SSI	Number 02T07-S1	DEMONSTRATION / DELIVERY HOLD **Parts Update** **RE: Upgrade Certain 2002 Model Year Windstar Vehicles Prior to Sale**

Date: March 2002

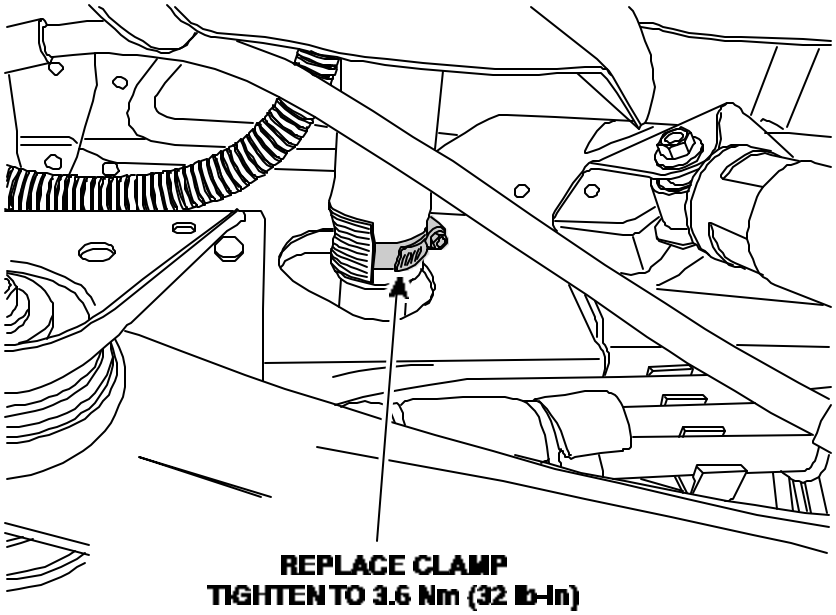
On all affected vehicles, an incorrect hose clamp is installed on the fuel tank filler hose that connects to the fuel tank. This condition may cause fuel odors or a MIL light to illuminate.

Technical Instructions	
	1. Raise the vehicle. 2. Completely unscrew the clamp and remove it from the fuel filler hose. 3. Install the new clamp and tighten it to 3.6 Nm (32 lb-in.). 4. Lower the vehicle.
